Access Compliance Report

Public Rights-of-Way

(Curb Ramps)

| Intersection ID: 3346 | Main Street: BARRISTER_WY | Cross Street: STEINBECK_CT | Location: S |

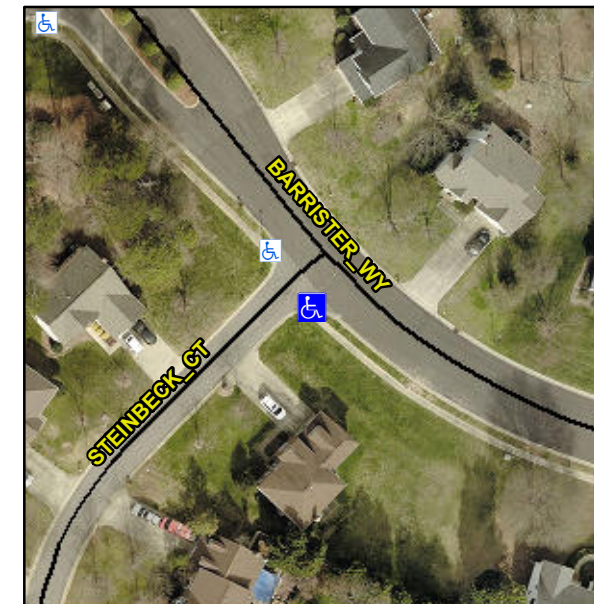
| ADA ID: 676F641952EB | Ramp Type: BlendTrans2 | Initial Pass/Fail: Fail | Overall Compliance: No |

Not Found, R304.5.1

| Compliance | Description | Data | Compliance | Description | Data |
|------------|-----------------------|-------|------------|-----------------------------|------|
| No | Ramp Width (in) | 43.0 | Yes | BlendTrans XSlope (%) | 0.2 |
| | | | No | Curb Slope (%) | 12.8 |

Remove & Replace Curb Ramp With Two New Directional Ramps or Equivalent.
